Response to U.S. EPR Design Certification Application RAI No. 197

Request for Additional Information No. 197 (2202), Revision 0

U. S. EPR Standard Design Certification

SRP Section: 19 - Probabilistic Risk Assessment and Severe Accident Evaluation

Figure 19-277-1
Hydrogen Mass in Containment for Transient Case Ca4_1c

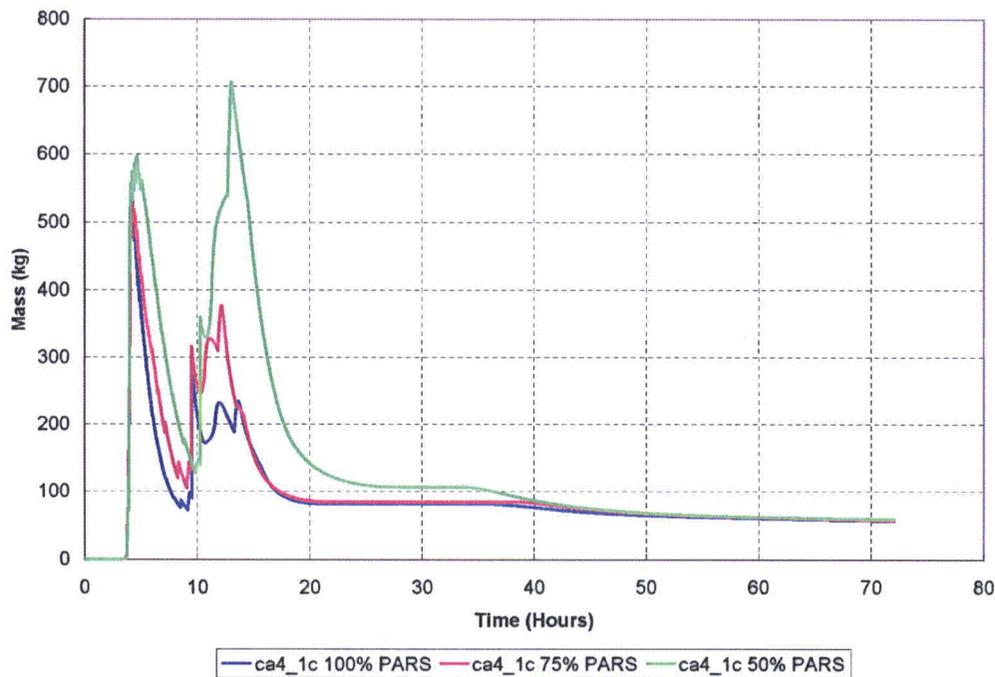
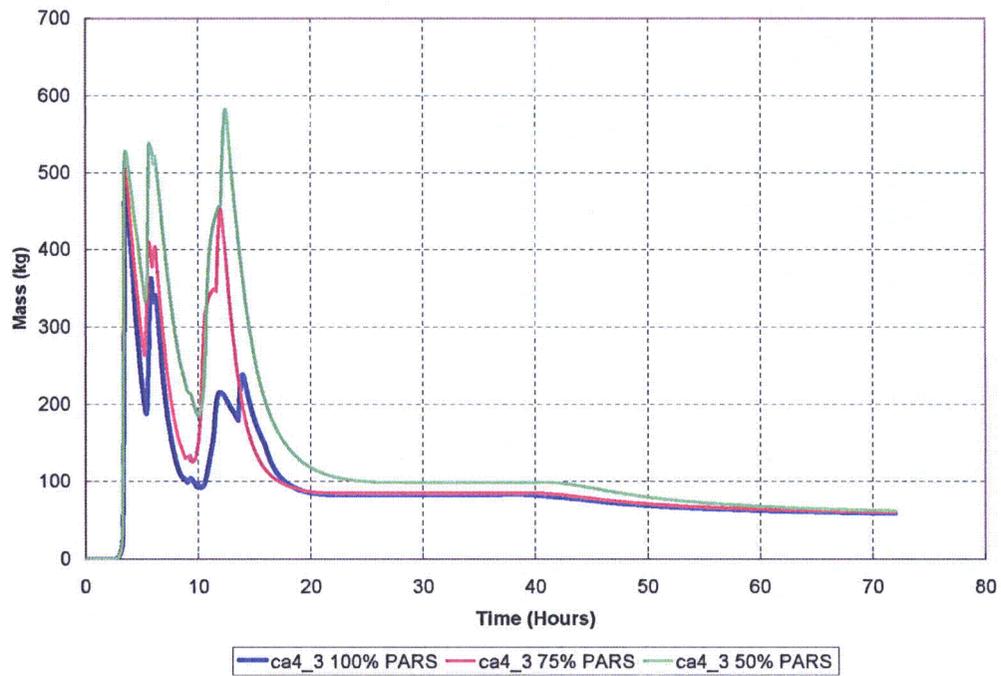
(Follow-up to Question 19-158) Revised FSAR Section 19.1.6.3.3.4, provided in response to Question 19-158, states that the passive autocatalytic recombiners (PAR) are used for control of hydrogen and oxygen following a severe accident at shutdown. FSAR Table 19.1-23 states that operation of the PARs is "implicitly assumed." Discuss whether this assumption applies to the Level 2 shutdown PRA as well, or whether failures of the PARs are modeled. If the PARs are assumed not to fail, discuss the availability controls that ensure they will function when needed (e.g., not be disabled by a protective covering while maintenance is done in containment). As appropriate, include the importance of the PARs as a risk insight in the FSAR.

Two scenarios were chosen to illustrate the impact of PARs availability. MAAP case Ca_4_1c is representative of a transient in state Ca and Ca_4_3 is representative of a loss of coolant accident (LOCA) in state Ca. Both cases were run with 100 percent, 75 percent and 50 percent PARs availability, as shown in Figures 19-277-1 and 19-277-2.

MAAP cases with 75 percent and 50 percent PARs availability show higher quantities of hydrogen in containment than the shutdown base cases with 100 percent PARs availability. These higher quantities are bounded by the mass of hydrogen used in the shutdown Level 2 PRA for the following reasons:

- With 50 percent PARs availability, the maximum quantities of hydrogen present in the containment for transient and LOCA cases are about 700 and 600 kg respectively, as seen in Figures 19-277-1 and 19-277-2.
- The Hydrogen mass of 940 kg used for deflagration load calculations in the shutdown Level 2 analysis was derived following the full power methodology. The full power study considered a bounding range of Zircaloy oxidation between 48 percent and 82 percent and, on the basis of the 82 percent upper bound, assumed a maximum mass of Hydrogen in containment. On this same basis of 82 percent upper bound, the assumed peak mass of hydrogen in containment at shutdown is 940 kg.

The containment failure probabilities following hydrogen deflagration loads derived in the shutdown Level 2 are unchanged in the case of partial unavailability of the PARs.

Figure 19-280-1
Containment Pressurization for Representative LLOCA run

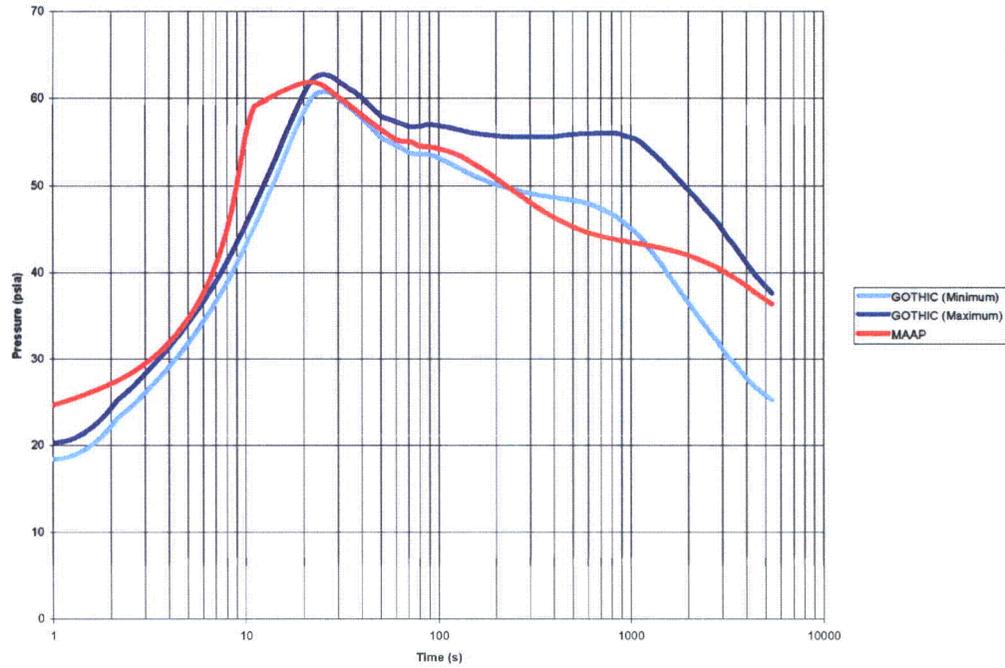
(Follow-up to Question 19-248) The response to Question 19-248(d) justifies excluding the switchover to hot leg injection from the PRA, but only addresses boron precipitation. FSAR Section 6.3.2.8, as well as ANP-10299, "Applicability of AREVA NP Containment Response Evaluation Methodology to the U.S. EPR™ for Large Break LOCA Analysis," Revision 0, state that hot leg injection is used to terminate core steaming. Justify the exclusion of this operator action with respect to termination of steaming. In addition, if the operator action (whether modeled in the PRA or not) is important to maintaining a low CDF and/or LRF, this risk insight should be included in the FSAR.

Hot leg injection is not credited in the PRA as a means to terminate steaming in a large LOCA. The analyses performed in FSAR Section 6 and in ANP-10299 used conservative assumptions, as required by the Standard Review Plan. Calculations performed with both GOTHIC and MAAP4, without the Standard Review Plan conservatisms for design basis analysis predicted containment pressures below the design pressure limits. Based on these calculations, the PRA estimates that, with or without hot leg injection, containment overpressurization is not likely to occur following a large LOCA.

When the conservative assumptions are removed, containment pressure response with cold leg injection alone did not result in the long term containment pressurization predicted in the design basis analysis, as discussed below.

shown in Figure 19-280-1. The figure shows comparable pressure responses between the two calculations. The maximum pressurization occurs during the early pressure peak, and is about 63 psia (49 psig), below the design pressure. Beyond the reflood phase (within a few hundred seconds), the mass and energy releases are dominated by decay heat. Decay heat was modeled consistently in these calculations. The difference in ECCS flows affects the amount of steaming and sensible heat addition and explains why the long term containment response predicted by MAAP is at the higher end of the range of responses predicted by GOTHIC.

It should also be noted that even if the containment design pressure of 62 psig was to be exceeded, this is not likely to result in a failure of the containment. The containment fragility evaluation performed for the Level 2 PRA showed that the probability of containment failure at 62 psig is approximately $1E-6$. To attain a probability of failure of one percent, the pressure would need to rise up to approximately 105 psig.
